**Biscay Gulf Western Interconnector**  
**Mission 2.10 – Canyon Head Bypass Feasibility Study**  
**Request for Contractor Information**  
**12<sup>th</sup> September 2017**

<b>Project Number</b>	P108-15
<b>Project Name</b>	Biscay Gulf Western Interconnector
<b>Report Title</b>	Mission 2.10 – Canyon Head Bypass Study
<b>Report Number</b>	RPA 016
<b>Client</b>	INELFE
<b>Client Contact</b>	Franck Rouquette, RTE José Antonio Delgado, REE
<b>Project Manager</b>	Jim Hodder
<b>Report Prepared By</b>	Jim Hodder & Peter Worrall

**Figure 2 – Detail of Proposed Inshore Cable Corridor at Capbreton**

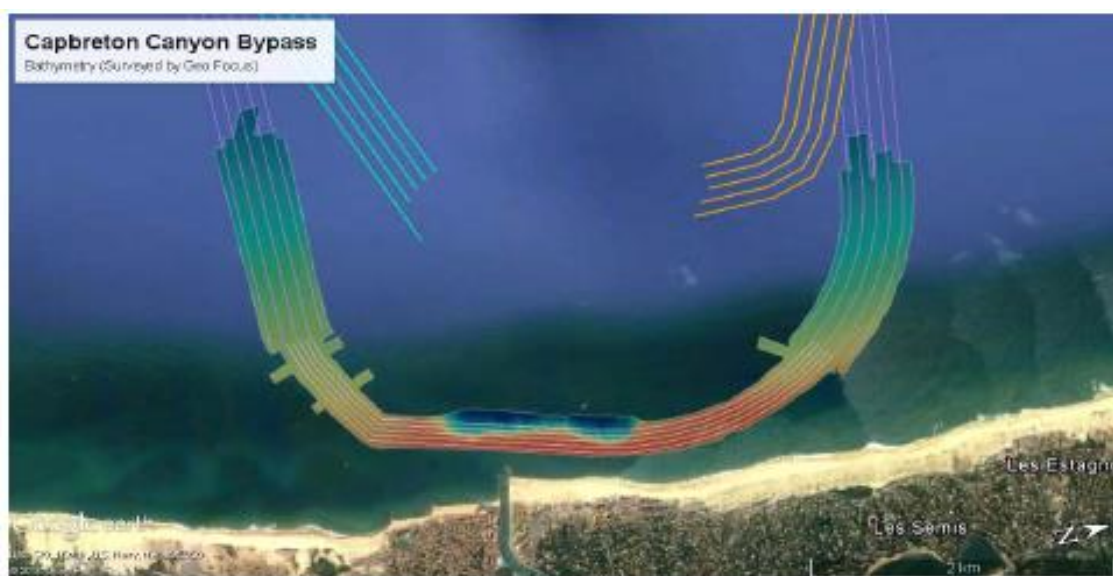
AssoDivers also comment that the proposed turns (alter-courses) on the nearshore route would be difficult to achieve without running the risk of damaging the neighbouring cables.

Figure 3 – Approximate Extent of Anchor Patterns for the Cable Installation Barge for Option 2

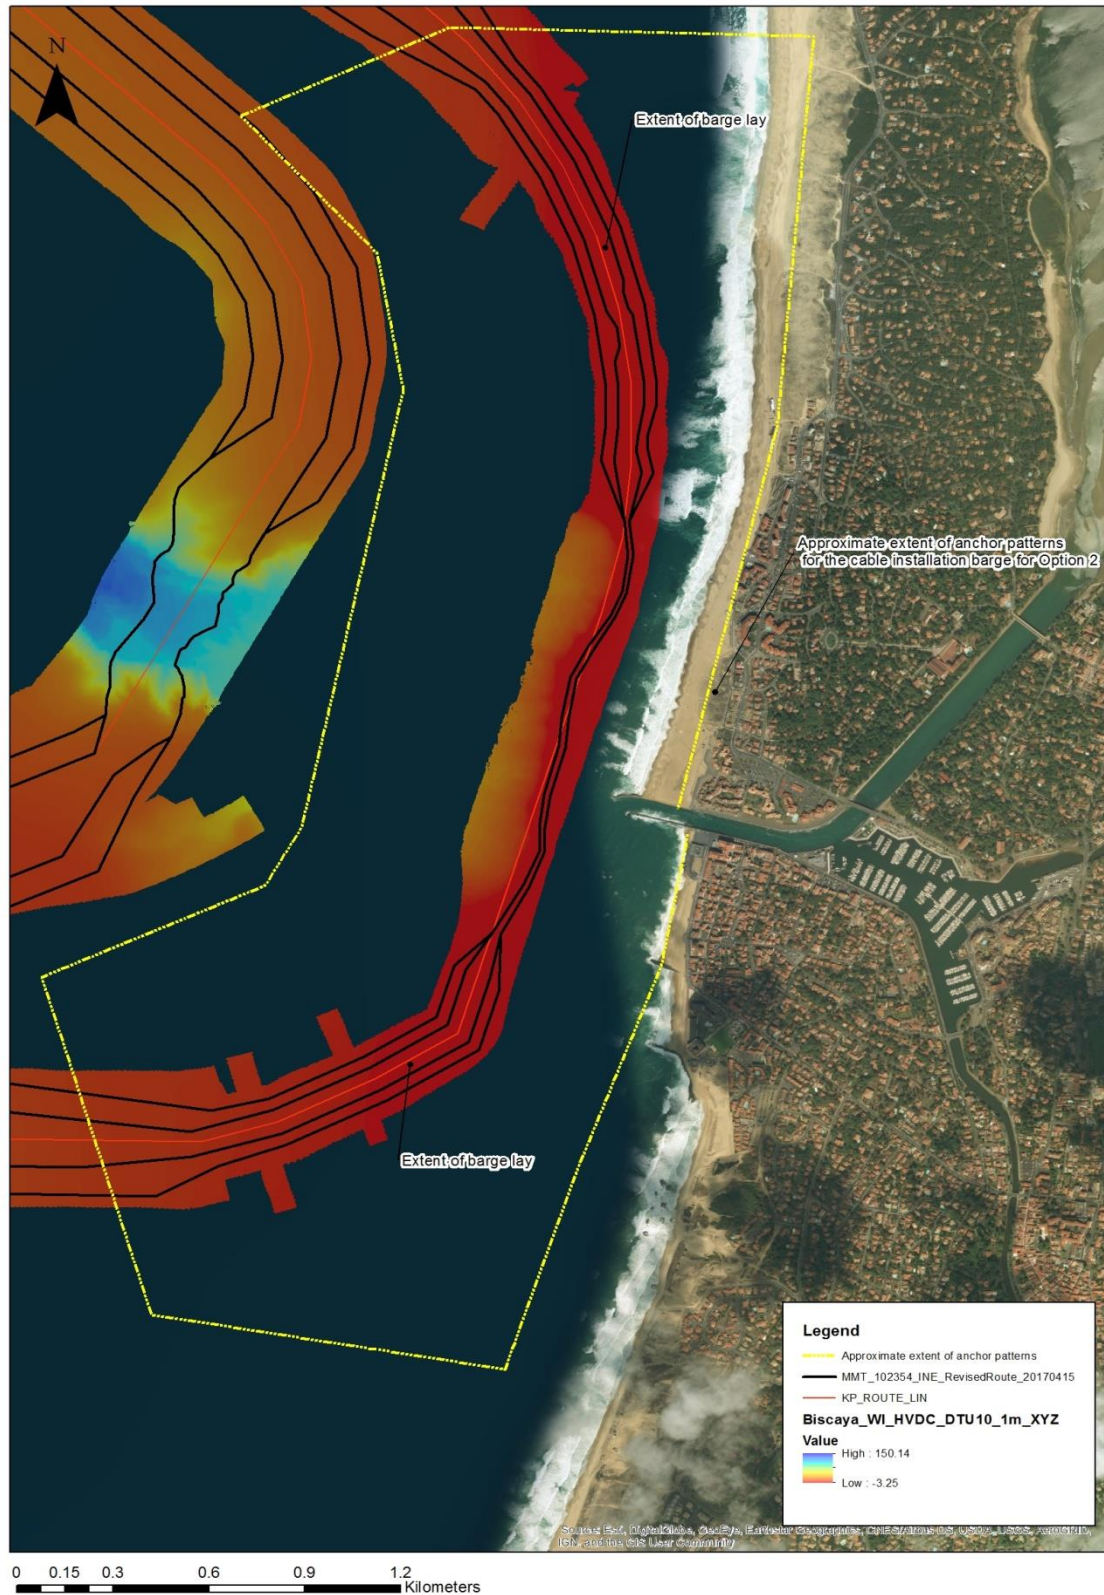
- The barge would need an anchor pattern of up to 2000m (north south) and 1000-1500m (east west). This would require some of the seaward anchors to be laid in/around the canyon, whilst the landward anchors would need to be located on or close to the beach/harbour area. The possible extent of the anchor patterns is shown in Figure 3.

- ***As shown in Figure 3, it is likely that the harbour entrance would need to be closed for the installation period, since vessels would not be allowed to come within a minimum of 500m of the barge operations for safety reasons.***
